January 31, 2006

Craig J. Wilson, Chief
Water Quality Assessment Unit
Division of Water Quality
State Water Resources Control Board
P.O. Box 100
Sacramento, CA 95812-0100
FAX: (916) 341-5550

Re: Comments on September 2005 Draft "Revision of California's Clean Water Act Section 303(d) List of Water Quality Limited Segments"

Figure 1: Malibu Creek dry weather nutrients and percentage of algae exceedances >30% coverage (11/98 – 11/04)

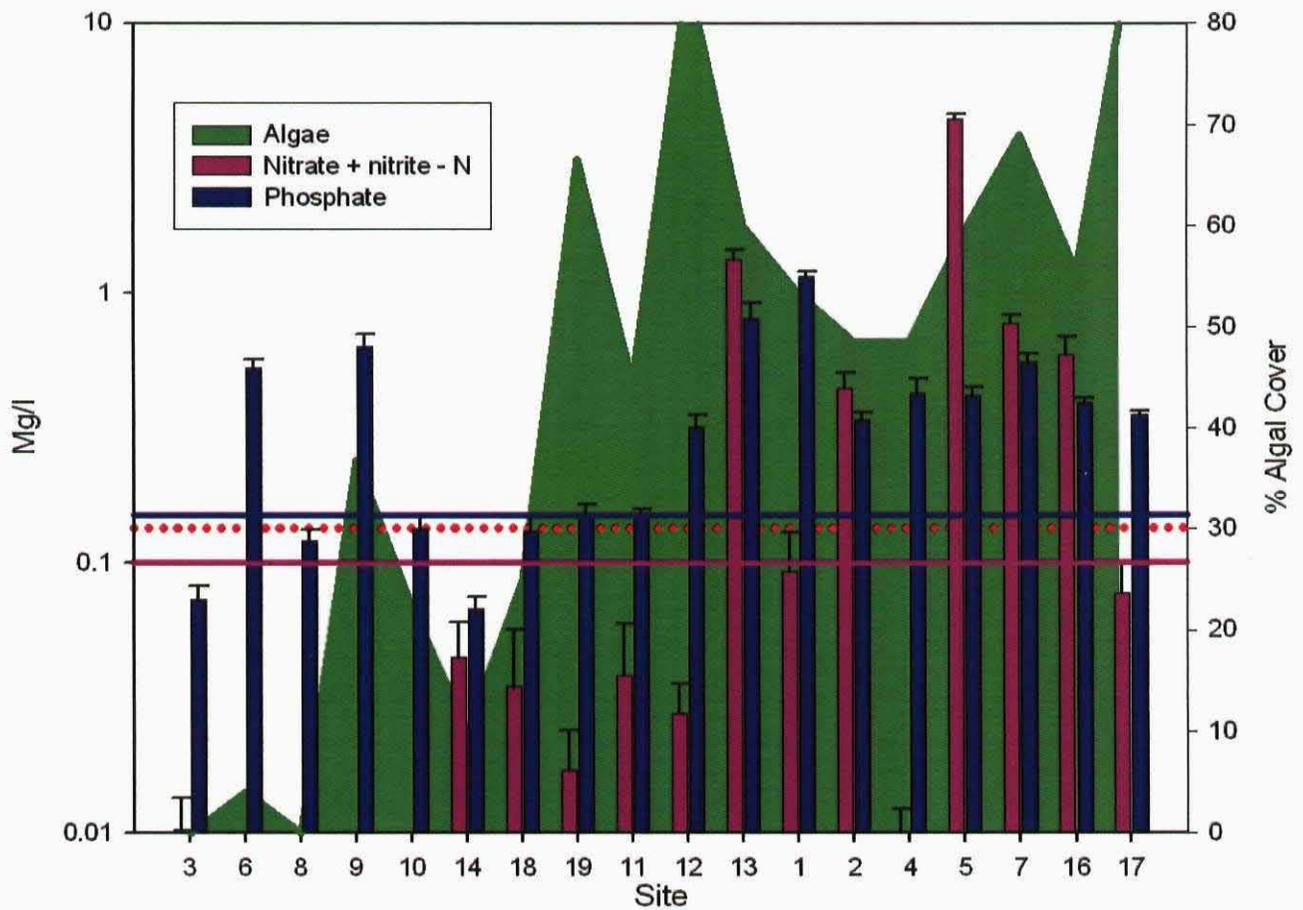
Similarly, data collected in the Malibu Creek Watershed by Heal the Bay's Stream Team show that elevated phosphate concentrations contribute to excess algal growth. Stream Team data collected between the period of November 1998 and November 2004 are represented in Figures 1 and 2. As seen in Figure 1, algal cover in Malibu Creek consistently exceeds 30% when nitrate is <0.05 mg/l and phosphate is above 0.15 mg/l. While nitrate is the limiting nutrient in this case, it would be nearly impossible to get the nitrate level any lower. Thus, decreasing phosphate concentrations would be a more effective means to reduce algal cover. Graphical representation of Site 12 in Figure 1 illustrates a situation where elevated phosphate levels and low nitrate levels lead to excess algal growth in over 80% of the samples. In addition, as shown in Table 2, data collected at the Agoura Hills Reference Site and Las Virgenes Creek Reference Site show that conditions with low nitrates and higher phosphates produce excess algae. Given the complexity of the nutrient issue, it is more prudent to list a segment for excess algae than for nitrates or nitrates and phosphates. This will ensure that all potential factors are

In sum, staff is not scientifically justified in making a blanket assumption that a nitrogen TMDL will fully address excess algal growth in a water segment. The State Board should correct this in reviewing the Draft Revisions.

Clearly staff is not justified in relying on the existence of these Nitrogen TMDLs to address excess algal growth. The State Board should make a finding that this approach is not scientifically sound.

Figure 1: Malibu Creek dry weather nutrients and percentage of algae exceedances >30% coverage (11/98 - 11/04)

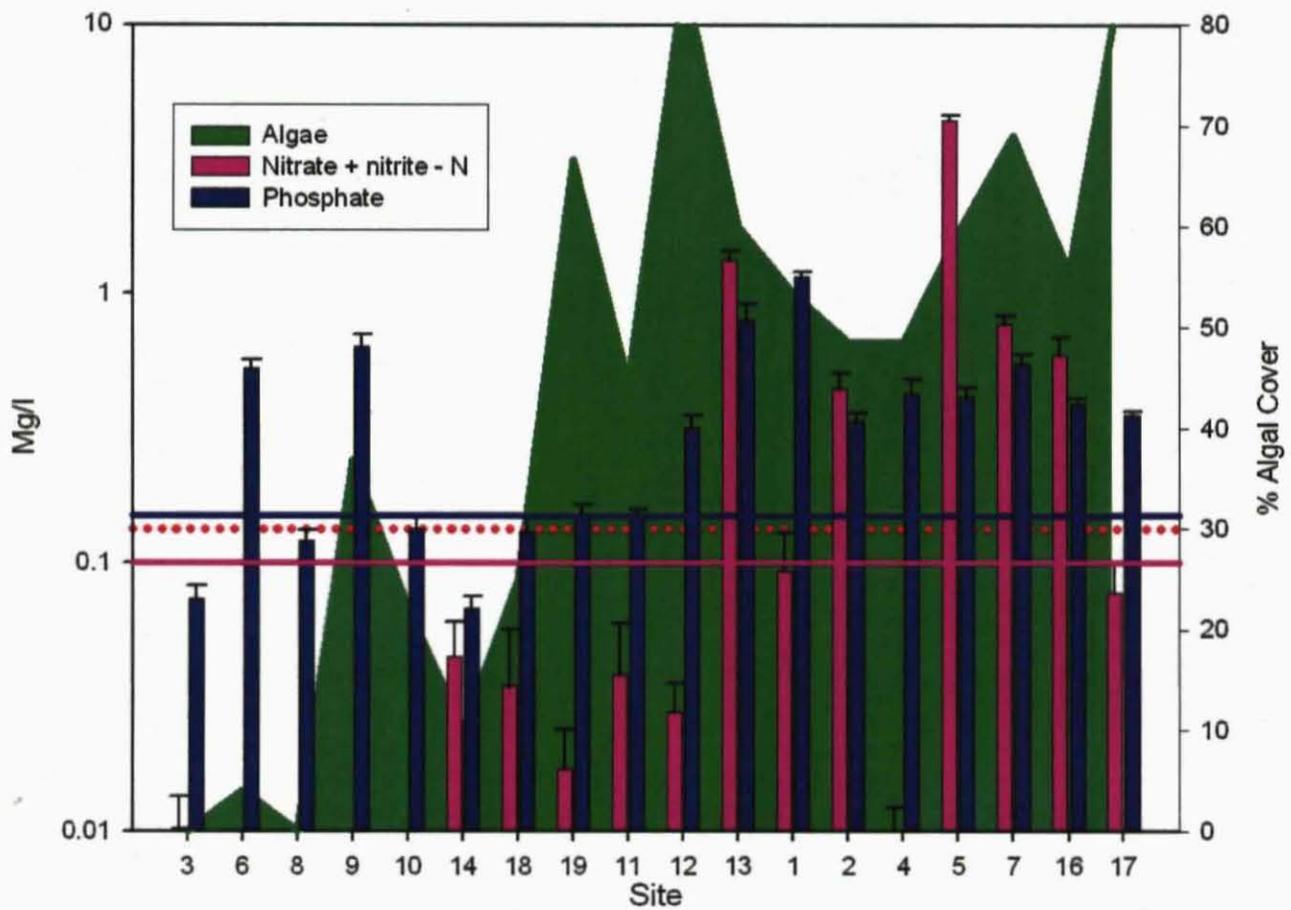
Similarly, data collected in the Malibu Creek Watershed by Heal the Bay's Stream Team show that elevated phosphate concentrations contribute to excess algal growth. Stream Team data collected between the period of November 1998 and November 2004 are represented in Figures 1 and 2. As seen in Figure 1, algal cover in Malibu Creek consistently exceeds 30% when nitrate is <0.05 mg/l and phosphate is above 0.15 mg/l. While nitrate is the limiting nutrient in this case, it would be nearly impossible to get the nitrate level any lower. Thus, decreasing phosphate concentrations would be a more effective means to reduce algal cover. Graphical representation of Site 12 in Figure 1 illustrates a situation where elevated phosphate levels and low nitrate levels lead to excess algal growth in over 80% of the samples. In addition, as shown in Table 2, data collected at the Agoura Hills Reference Site and Las Virgenes Creek Reference Site show that conditions with low nitrates and higher phosphates produce excess algae. Given the complexity of the nutrient issue, it is more prudent to list a segment for excess algae than for nitrates or nitrates and phosphates. This will ensure that all potential factors are

Clearly staff is not justified in relying on the existence of these Nitrogen TMDLs to address excess algal growth. The State Board should make a finding that this approach is not scientifically sound.
